1st Review
Aurora Water
Jennifer Wynn
jwynn@auroragov.org

Highline Village 4
Apartments

HIGHLINE VILLAGE 4 APARTMENTS
SITE PLAN AND PRELIMINARY PLAT
LOT 2, BLOCK 1 HIGHLINE VILLAGE,
CITY OF AURORA, COUNTY OF ADAMS, STATE OF COLORADO
3.741 ACRES

GABION SEAT WALL
NOT TO SCALE

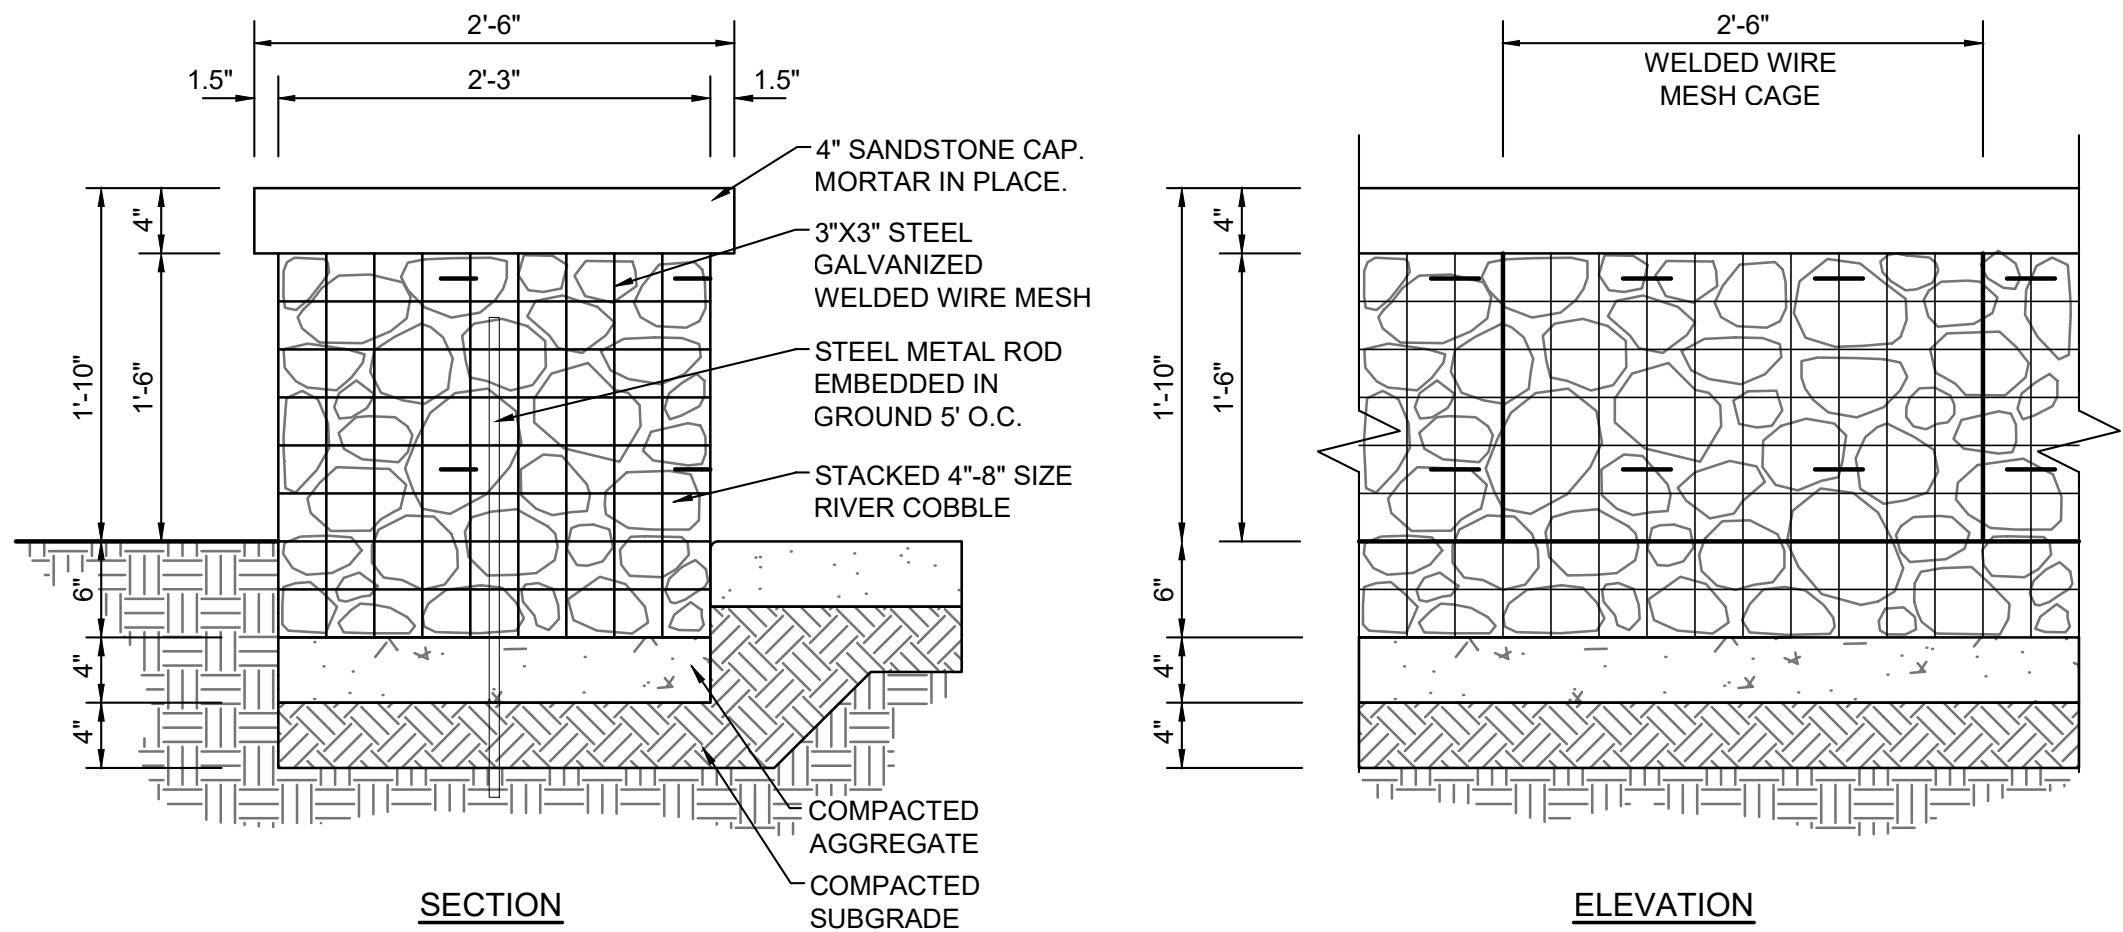
Add these signs to detail sheet.

Replace this detail with the one above.
Revised, see plans.

GRADING PLAN 1 OF 2

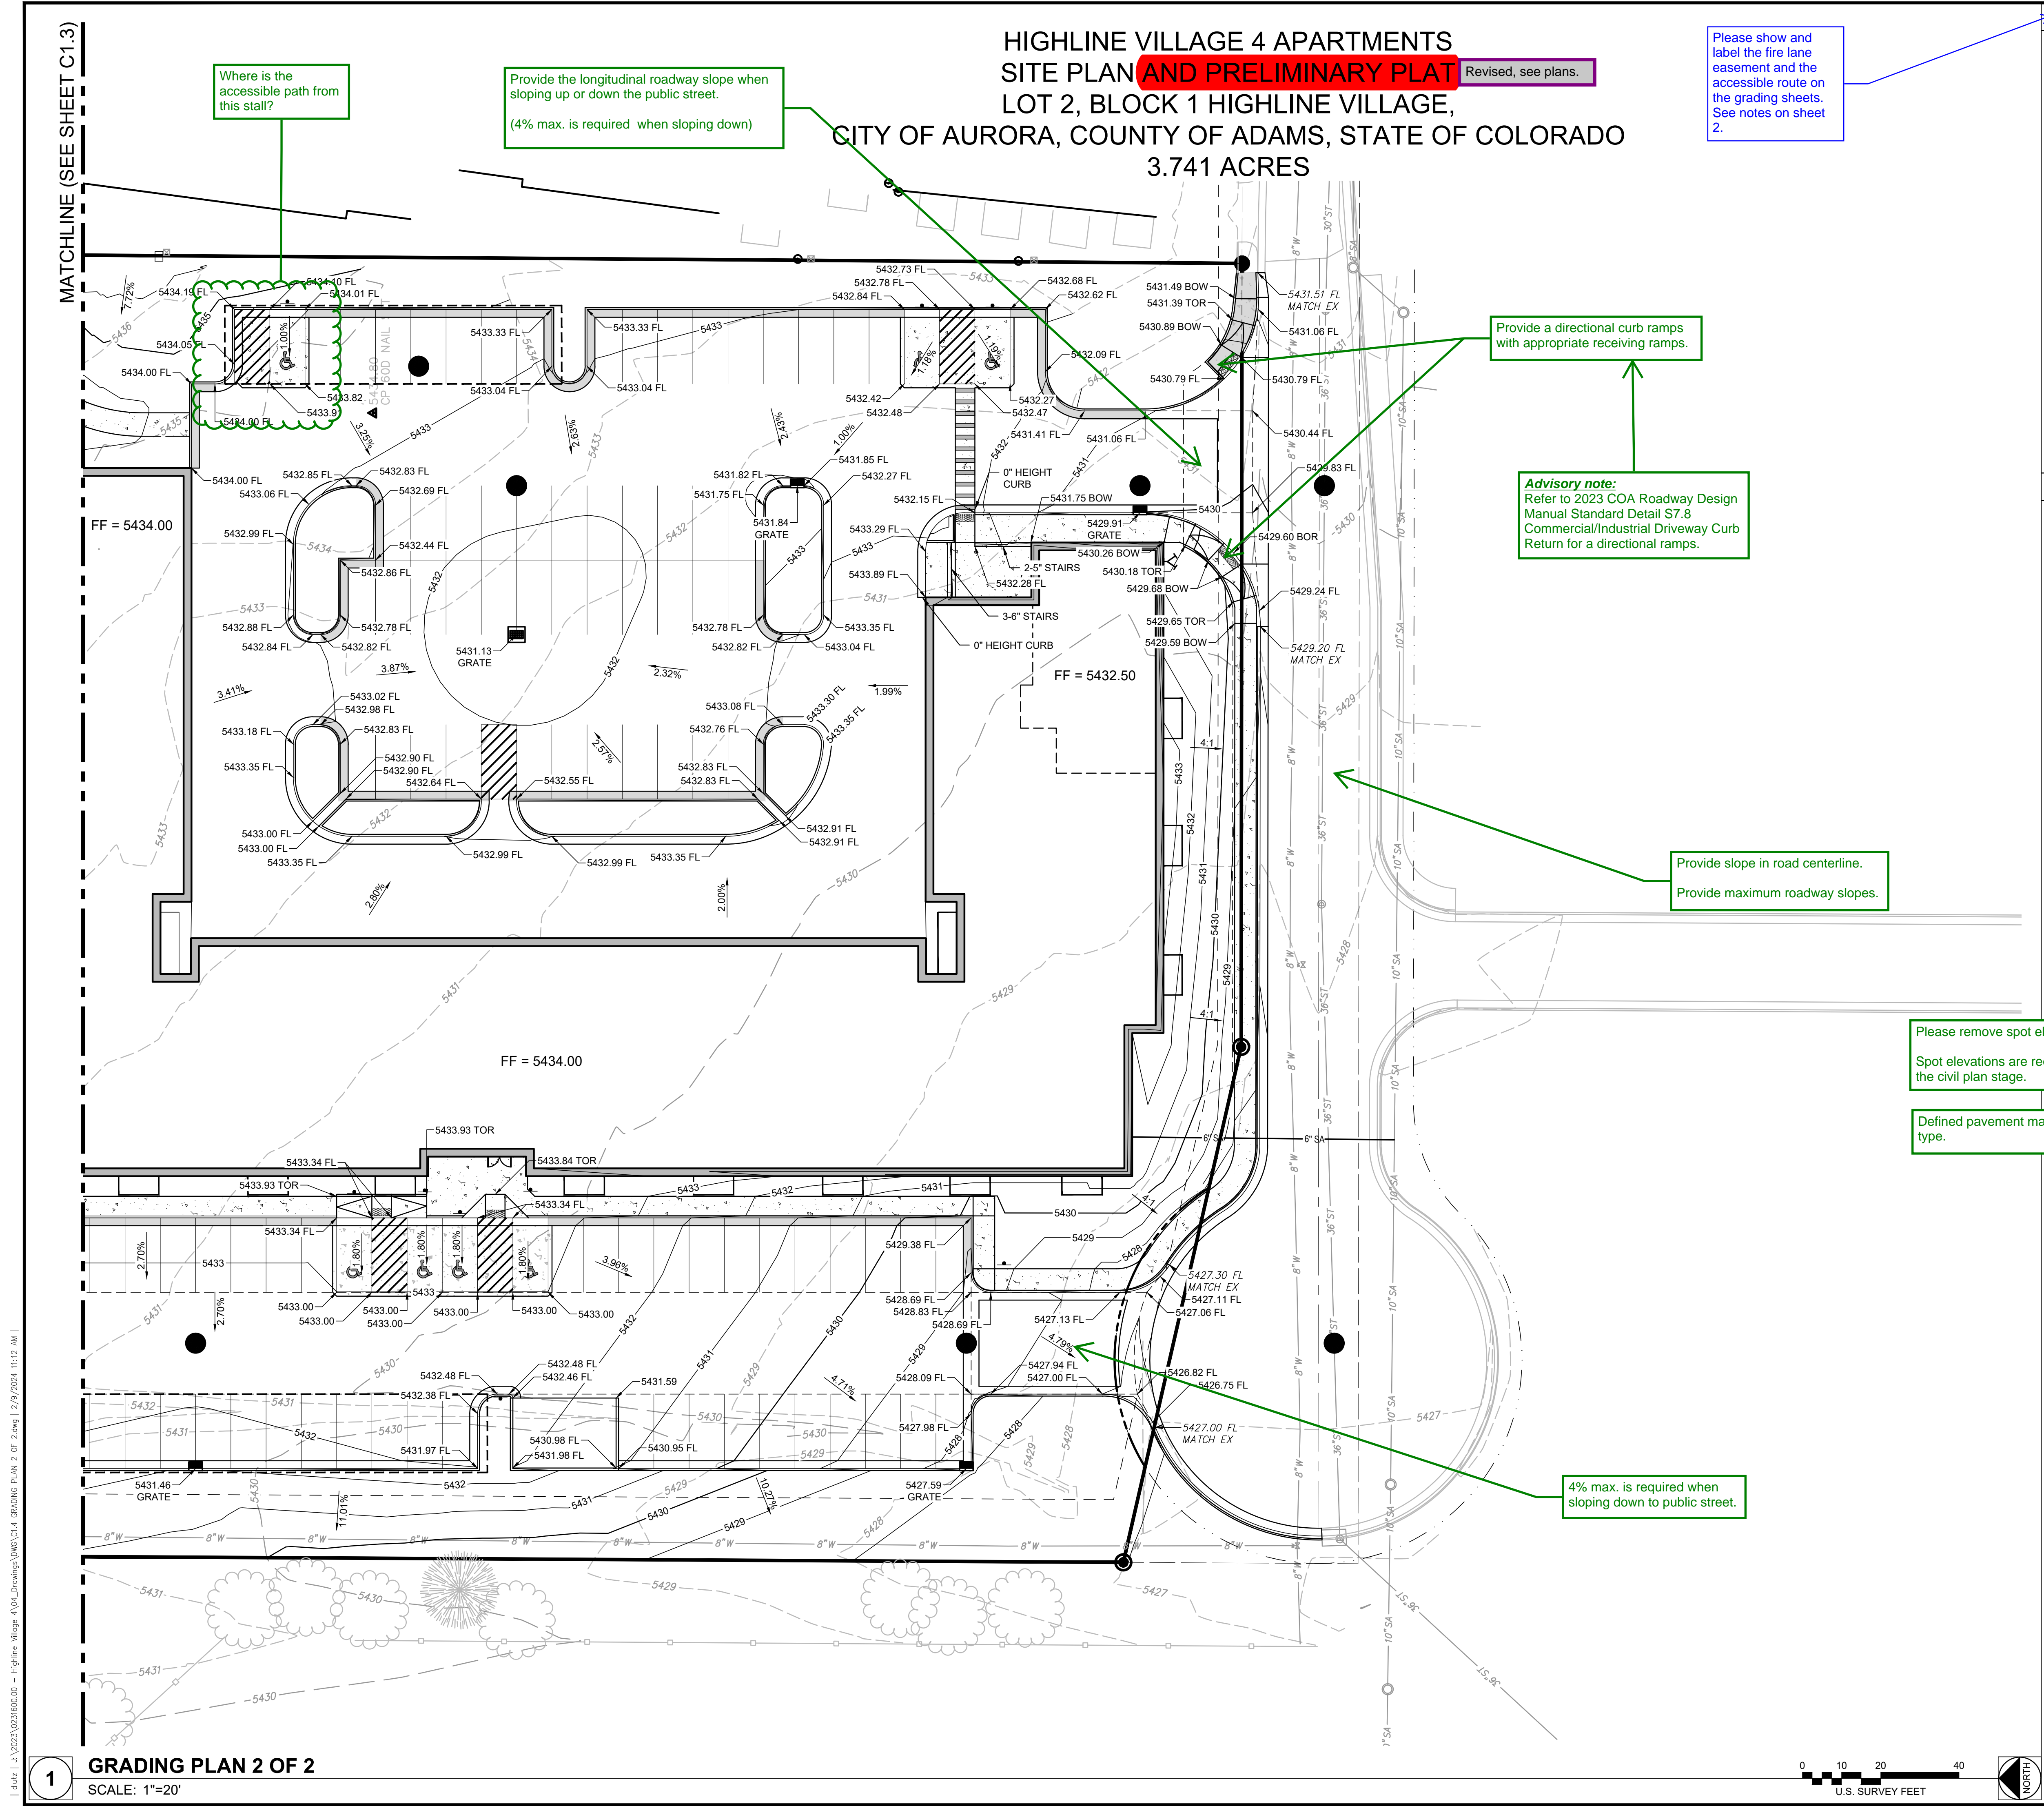
Please show and label the fire lane easement and the accessible route on the grading sheets. See notes on sheet 2.

Revised, see plans.

1 UTILITY PLAN
SCALE: 1"=30'

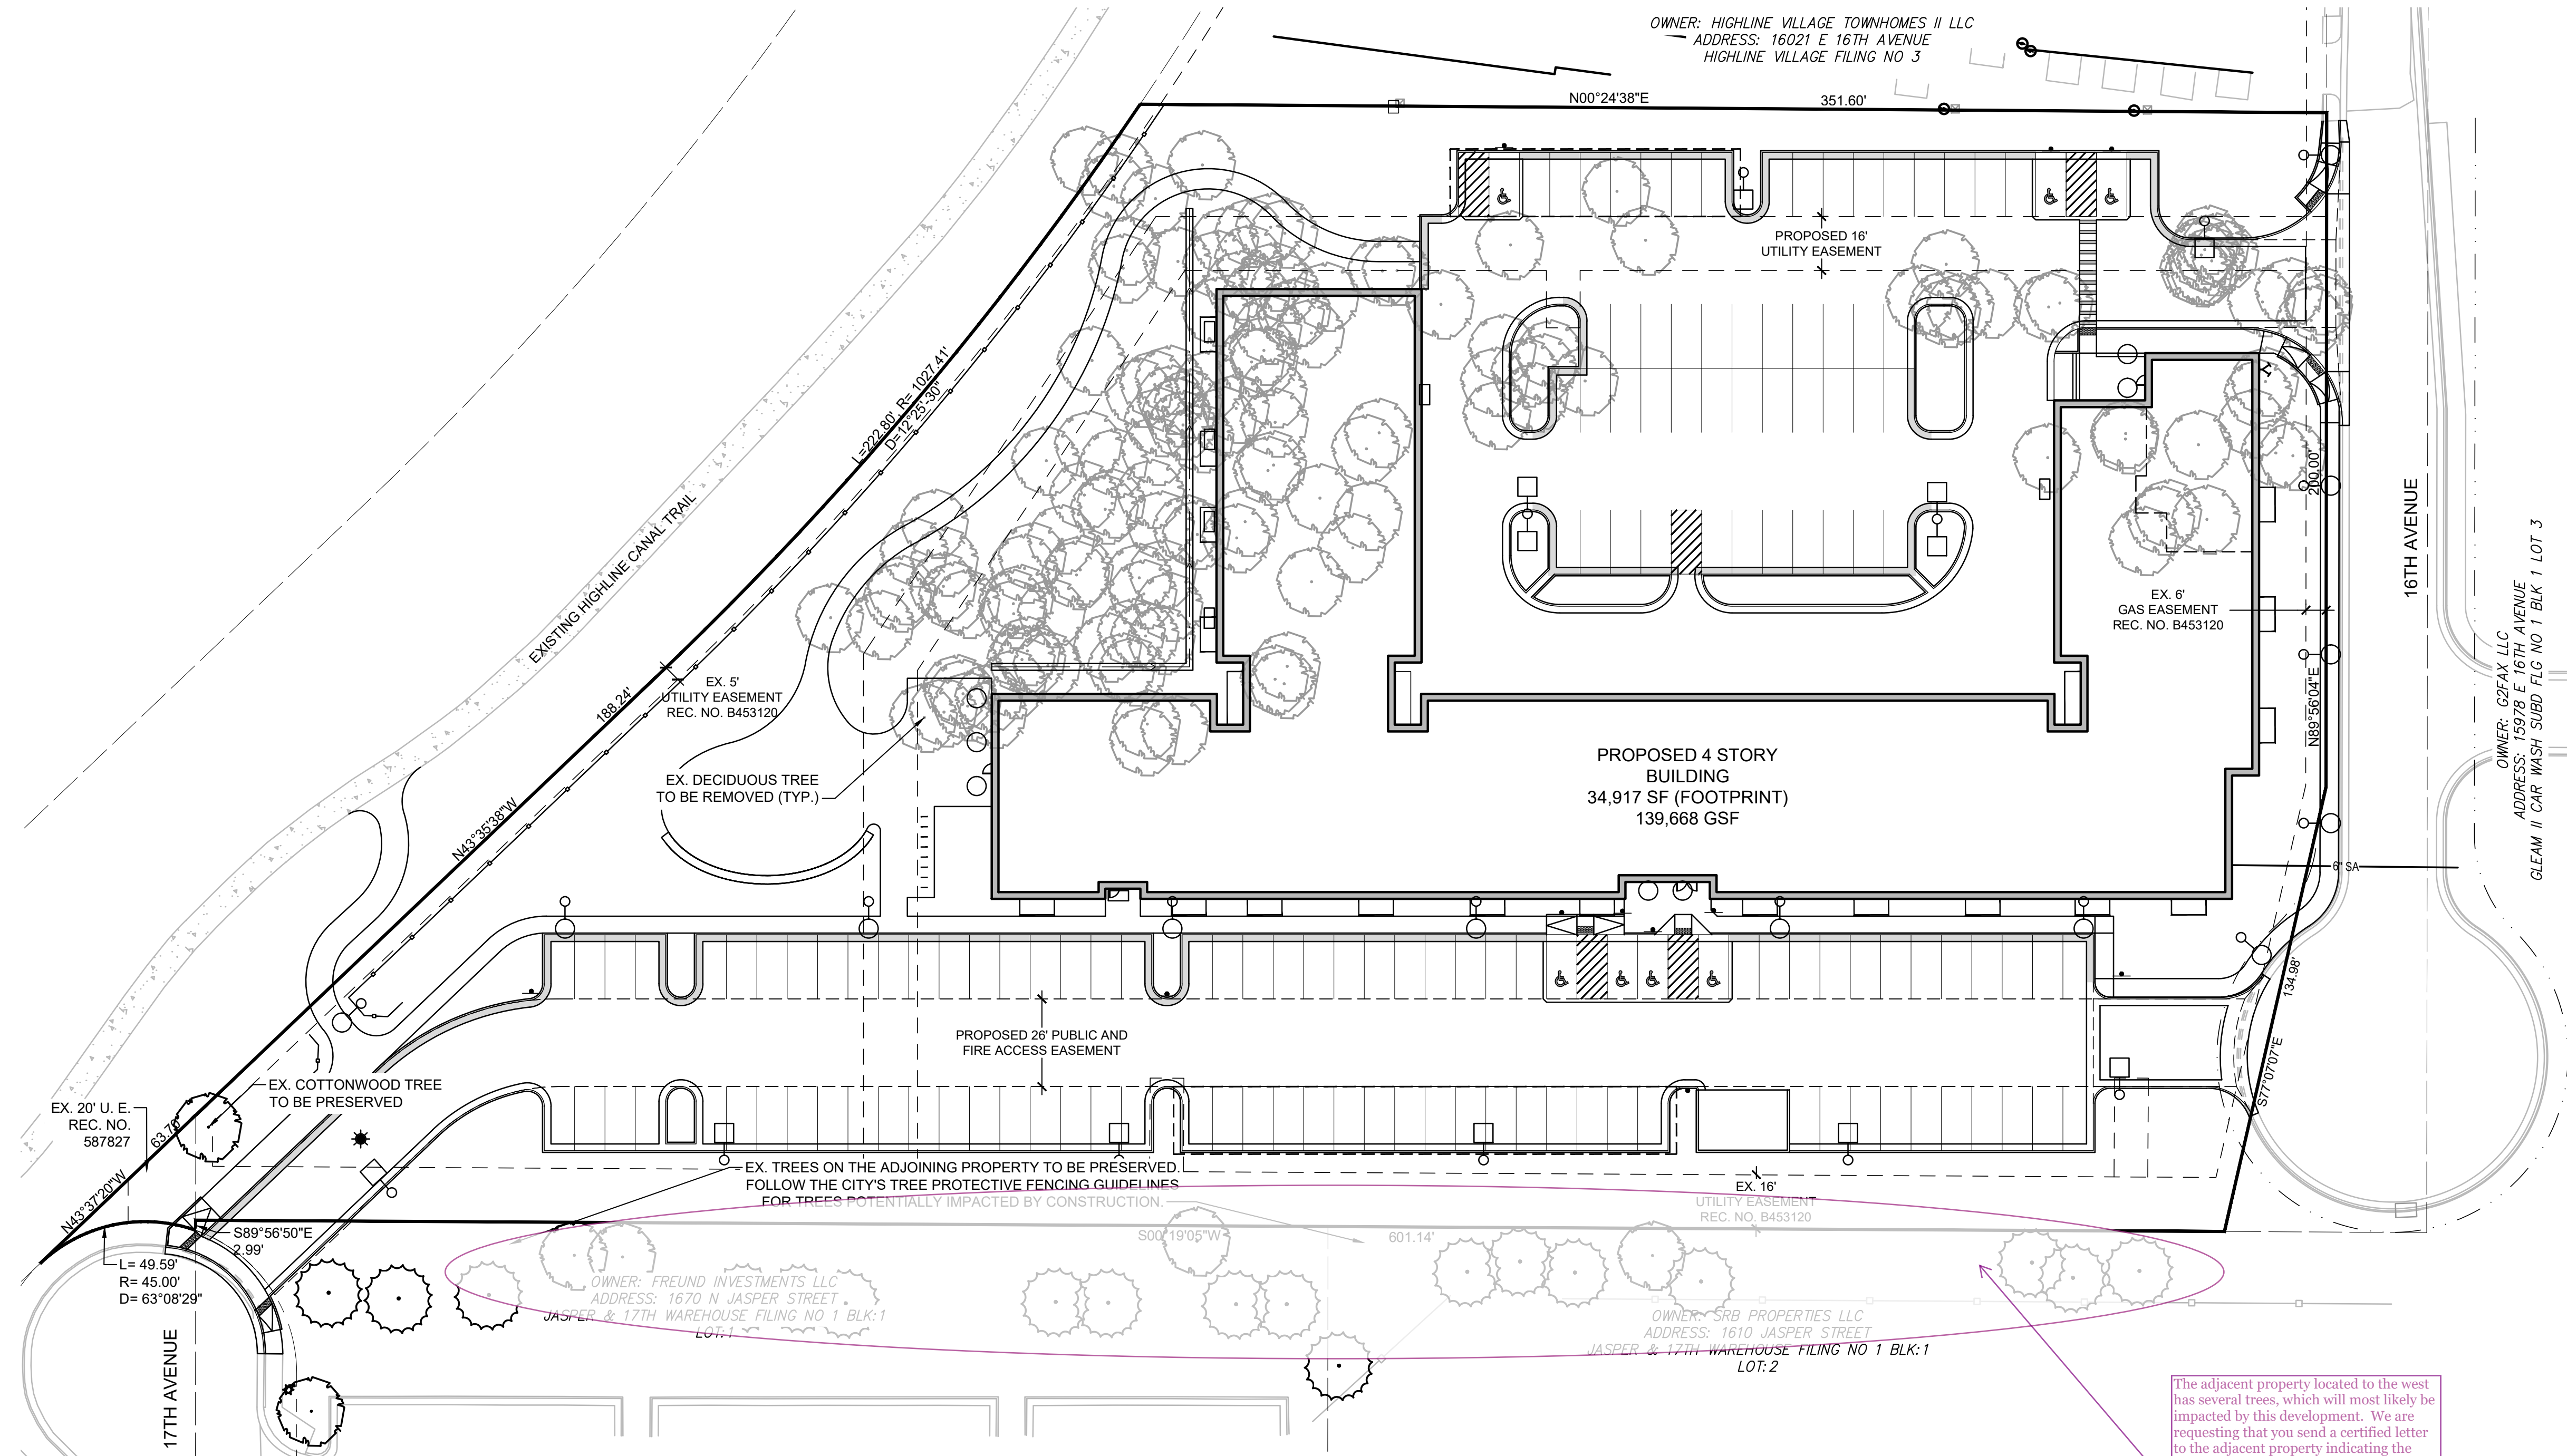
Show connection to
existing water
system.

Label existing
hydrant.

Minimum length for
fire hydrant laterals
is 5ft, and hydrant
must be at least 3.5ft
from curb. Please
dedicate separate
easement for
hydrant.

Water mains should
be 5ft from curb and
gutters, see AW
Spec 5.04 for more
info

We do not allow
size-on-size wet
taps, please revise to
be a cut-in tee
connection

This manhole should
be public

3" meter vaults must
be 18ft wide and 5ft
behind meter. See
AW Spec 5.04 for
more info.

This easement line is
not represented on
proposed plat pages

See notes on Sheet 2
regarding hydrant
placement.

Please call out as 4ft
MH connection

Please format key so
it is easier to
understand which
label goes with
which number,
specifically numbers
4, 5, 6, and 7.

Revised, see plans.

TREE MITIGATION
PLAN

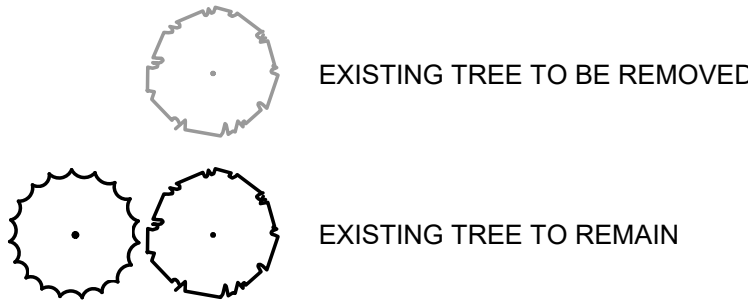
Aurora Forestry cannot approve plan until tree mitigation has been paid.

The adjacent property located to the west has several trees, which will most likely be impacted by this development. We are requesting that you send a certified letter to the adjacent property indicating the methods used to protect these trees, as well as remedies as a result of potential damaged incurred from the development. Please provide the City of Aurora a copy of this letter including the date sent and received

Revised, see plans.
